SAN ANTONIO WATER SYSTEM
S&S HILLS SUBDIVISION 12-INCH WATER LINE
EXTENSION PROJECT

SAWS Job No. 09-7008,
Solicitation No. B-10-037-DG

ADDENDUM NO. 1

June 11, 2010

C2
SHEET

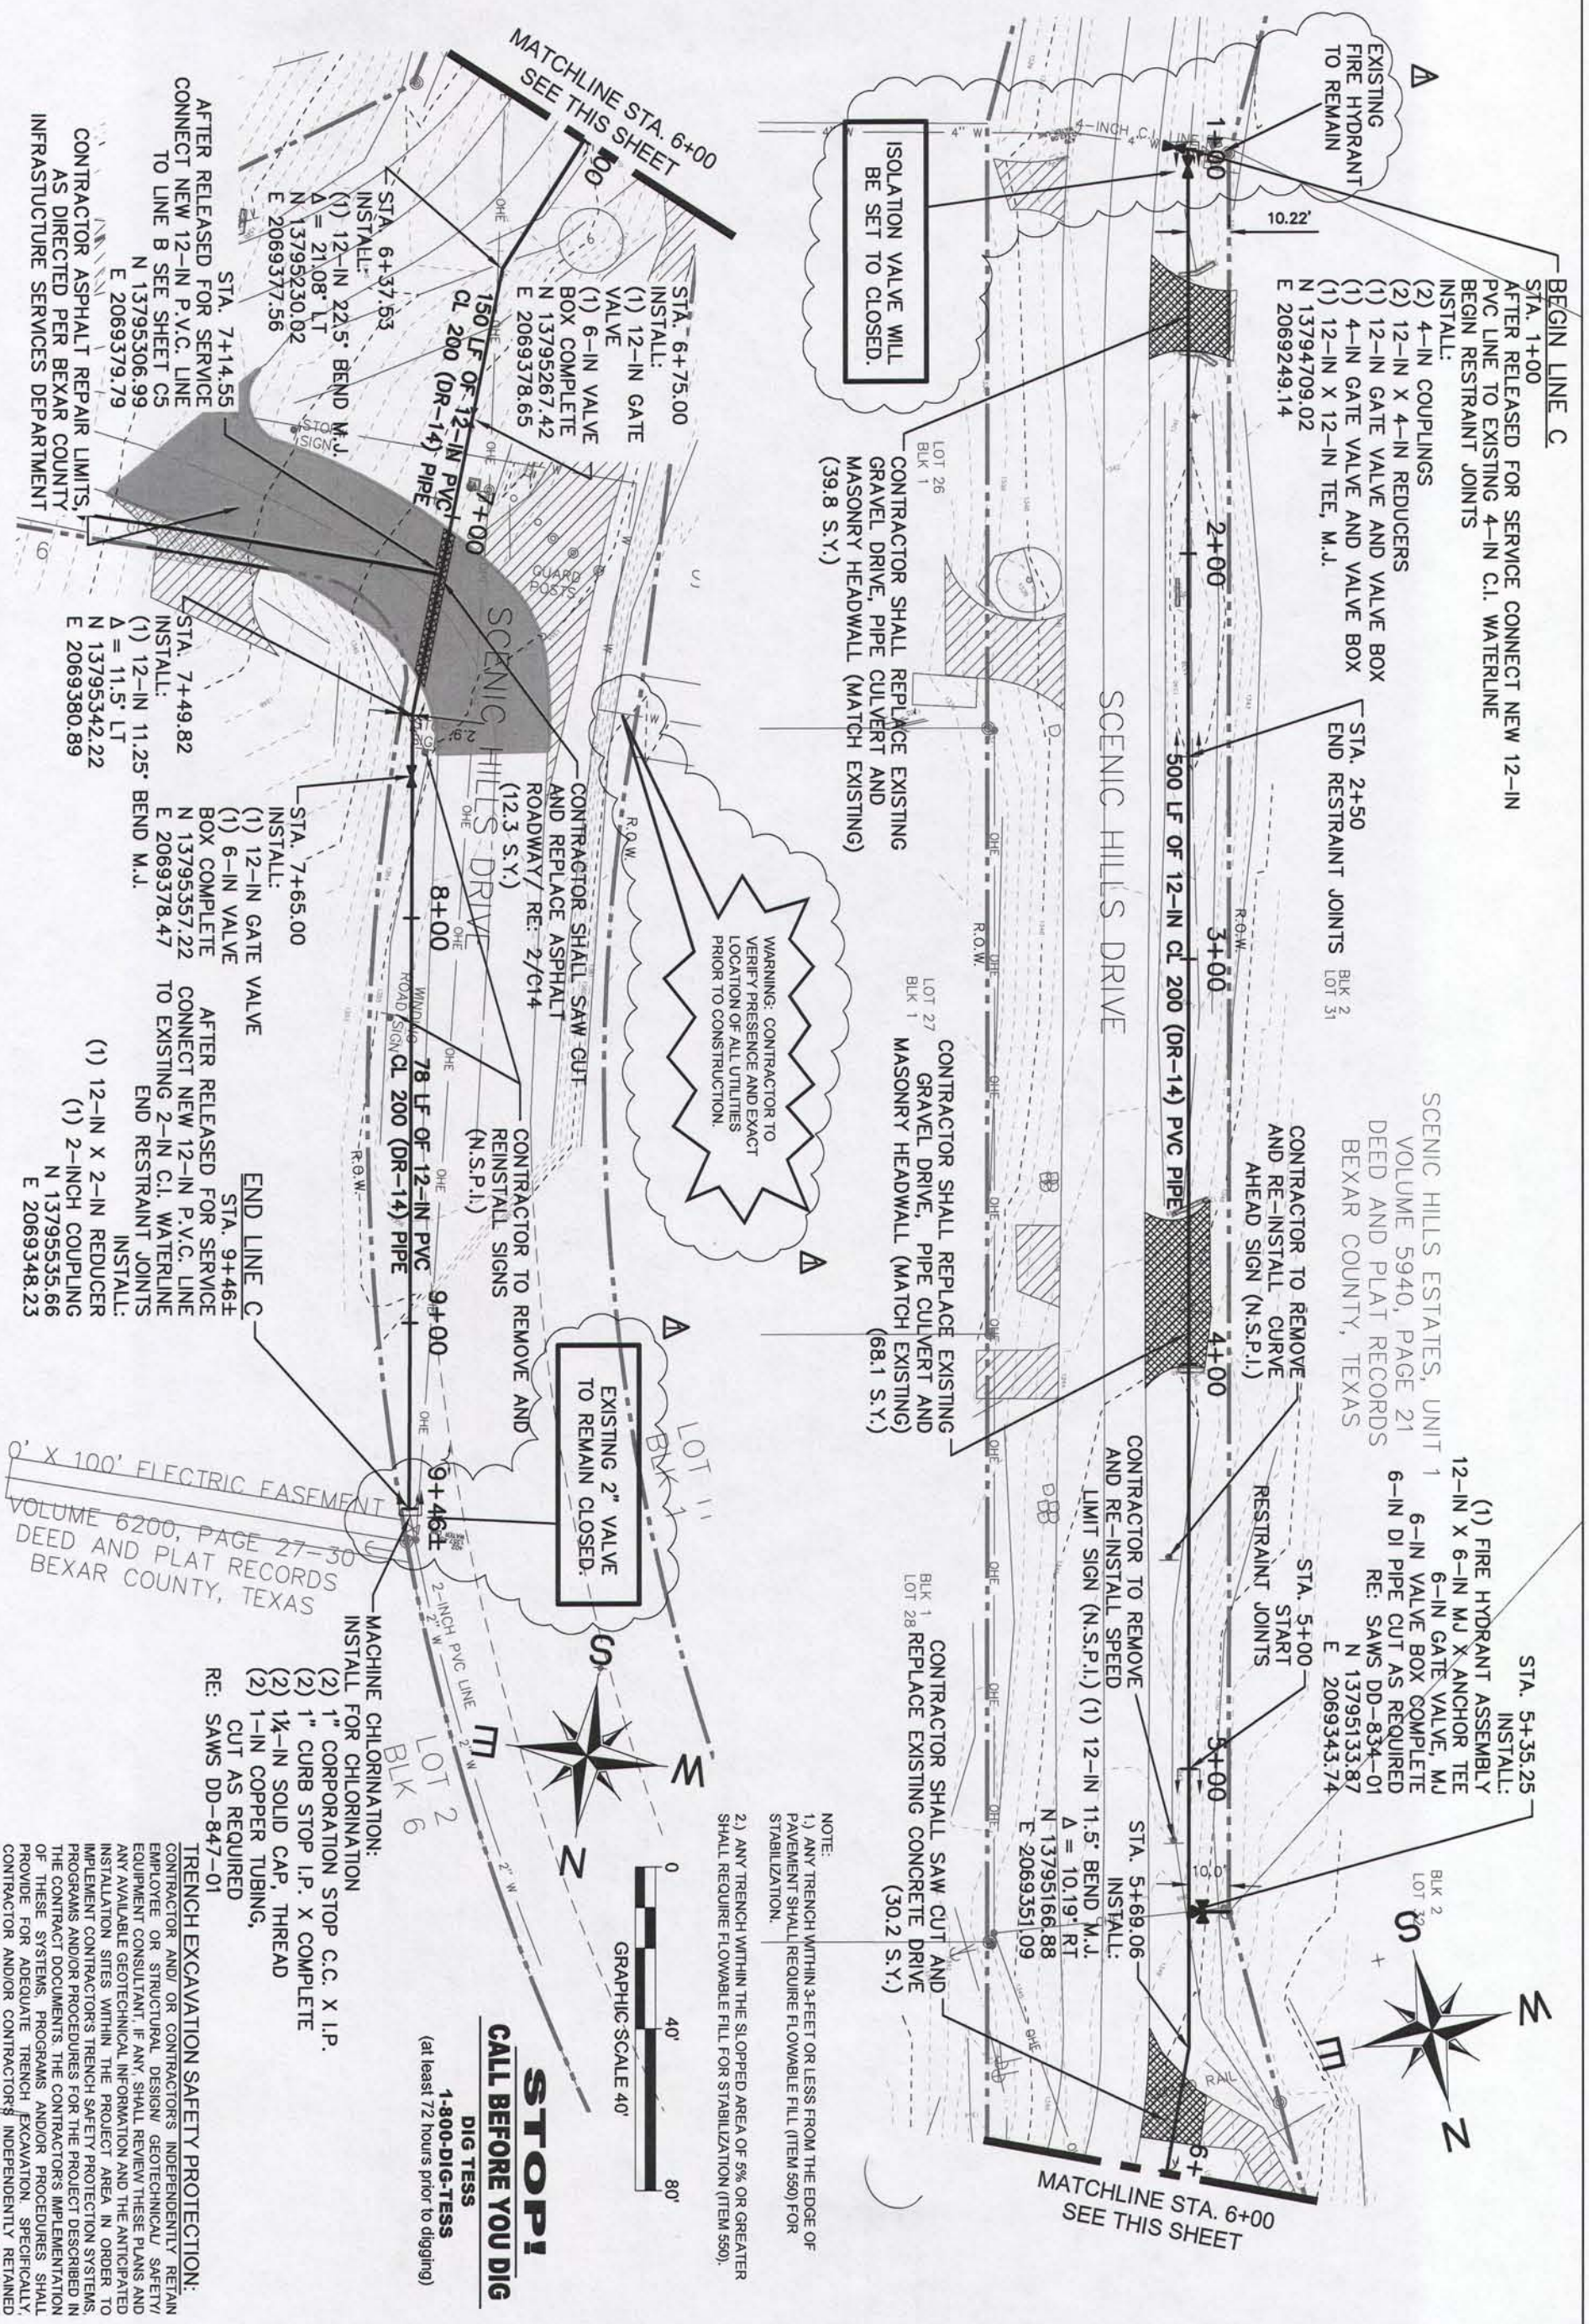
A. Sheet C2, NOTES, SHEET INDEX AND LEGEND SHEET – Quantities Tables has been updated to reflect new pipeline quantities.

PRESSURE REDUCING VALVE DETAIL

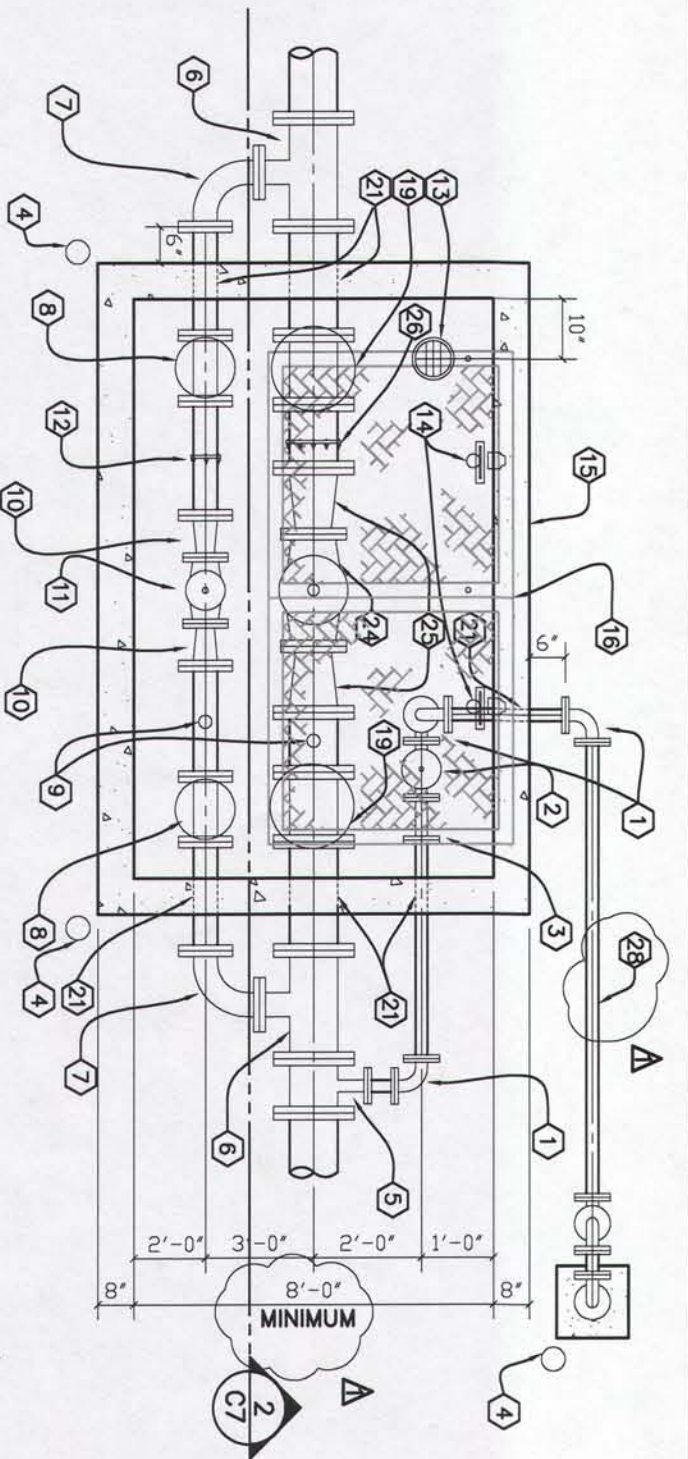
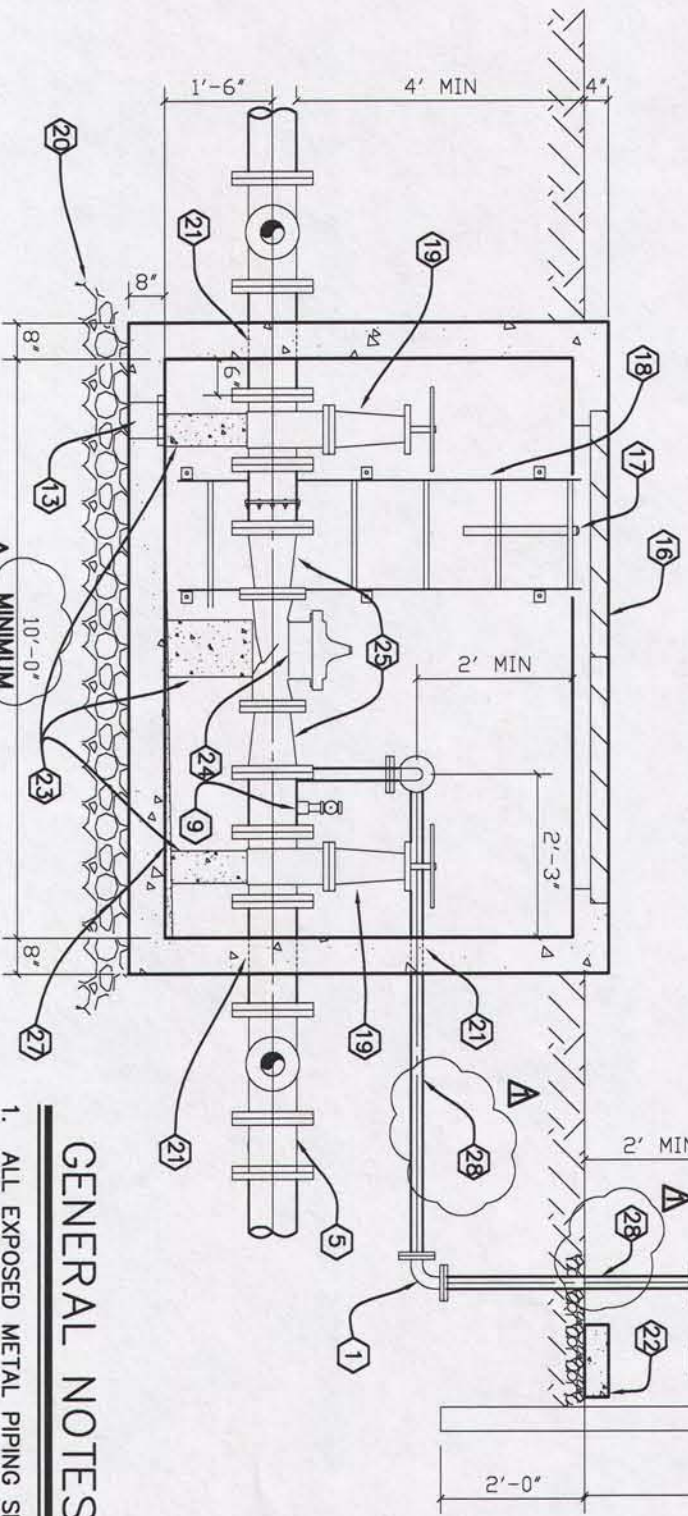
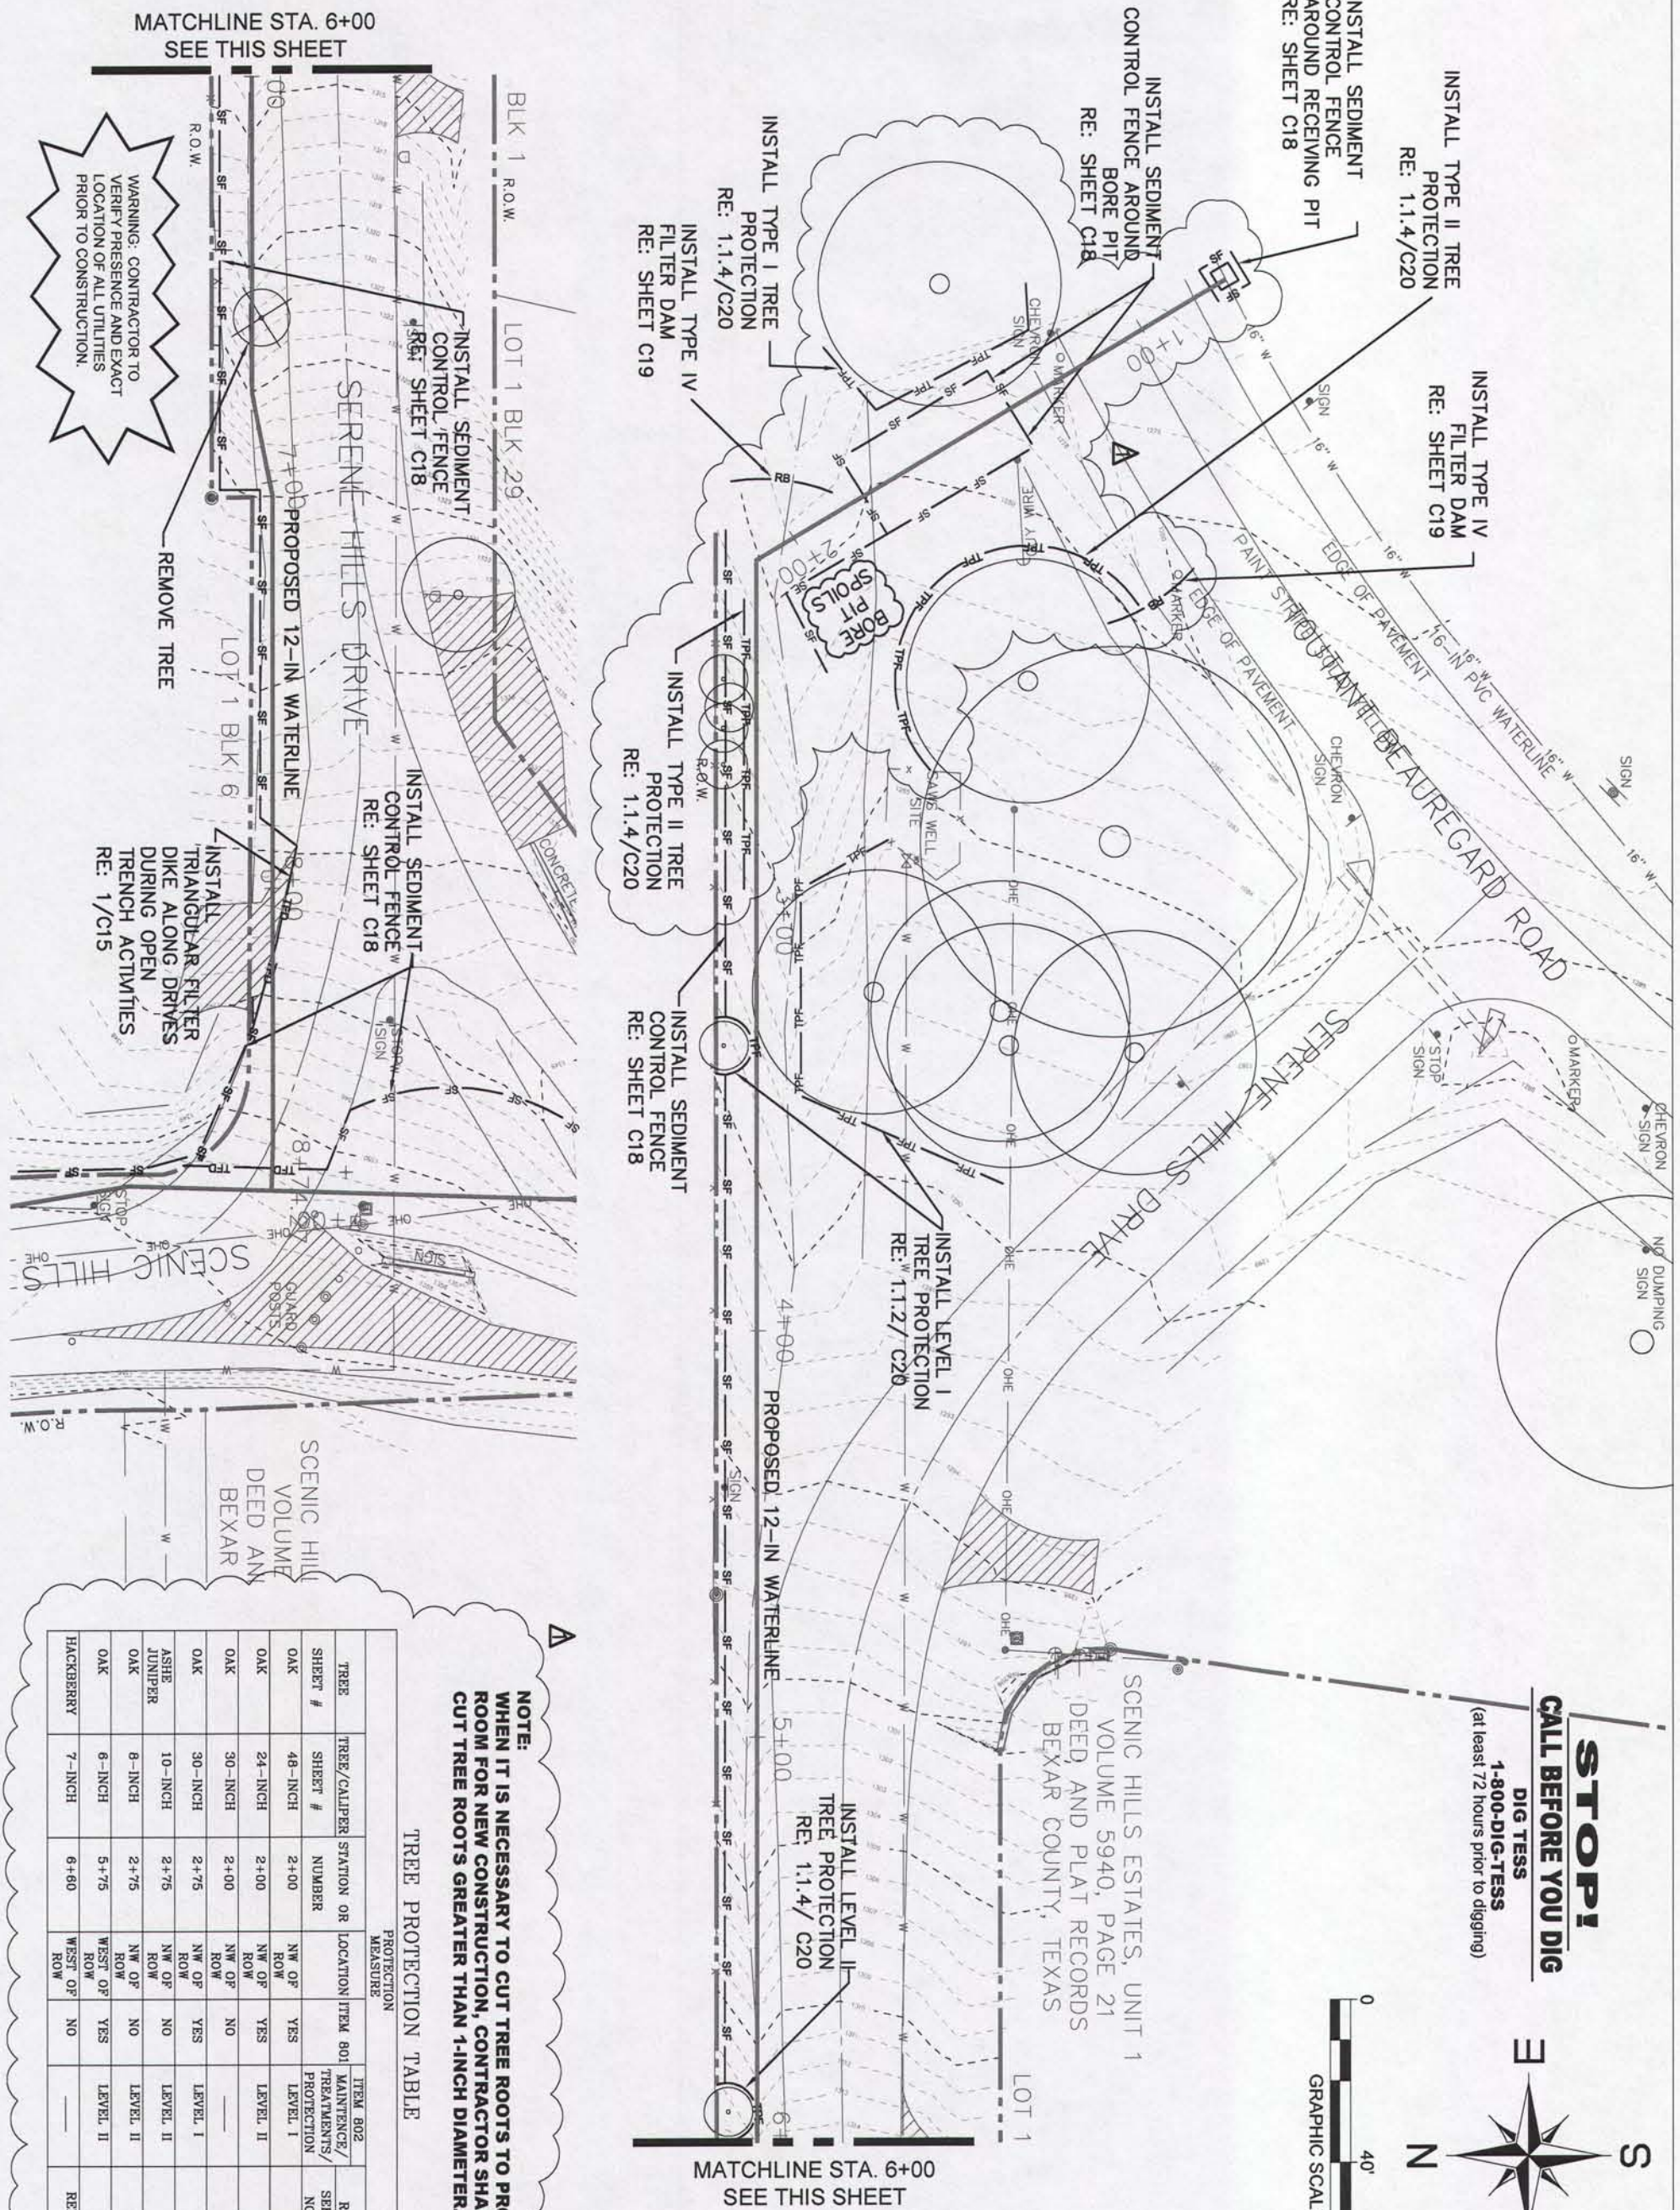
- Q2.** Can the concrete vault be a larger than 10-ft x 8-ft?
- R2.** The vault dimensions shown on the plans are the minimum allowable dimensions for the concrete vault. A larger concrete vault maybe used, provided the PRV assembly is centered horizontal within the vault.

- Q7** The pipe material for the 2-inch line has not be indentified for the PRV assembly? Will SAWS allow a 2-inch galvanized pipe?
- R7** Sheet C8, SAWS Detail DD-901-06 specifies the pipe material to be steel.

E. Sheet C7, PRESSURE REDUCING VALVE DETAIL – Revisions include:

- i. INSERTED “MINIMUM” to the concrete vault dimensions:
- ii. INSERTED Item 28 for the 2-inch Steel Pipe.
- iii. LABELED 2-inch pipe material on Pressure Reducing Valve Detail 1 and 2.

TEMPORARY EROSION AND SEDIMENTATION CONTROL AND TREE PROTECTION SHEET 2 OF 3

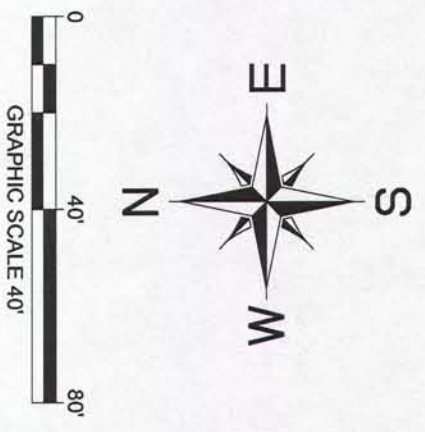
F. Sheet C16, TEMPORARY EROSION AND SEDIMENTATION CONTROL AND TREE PROTECTION – Revisions include:

- i. ADDED additional tree protection near 16-inch waterline tie-in.
- ii. INSERTED the following note:
“WHEN IT IS NECESSARY TO CUT TREE ROOTS TO PROVIDE ROOM FOR NEW CONSTRUCTION, CONTRACTOR SHALL SAW CUT TREE ROOTS GREATER THAN 1-INCH DIAMETER.”
- iii. UPDATED Tree Protection Table to reflect additional trees within the project area.
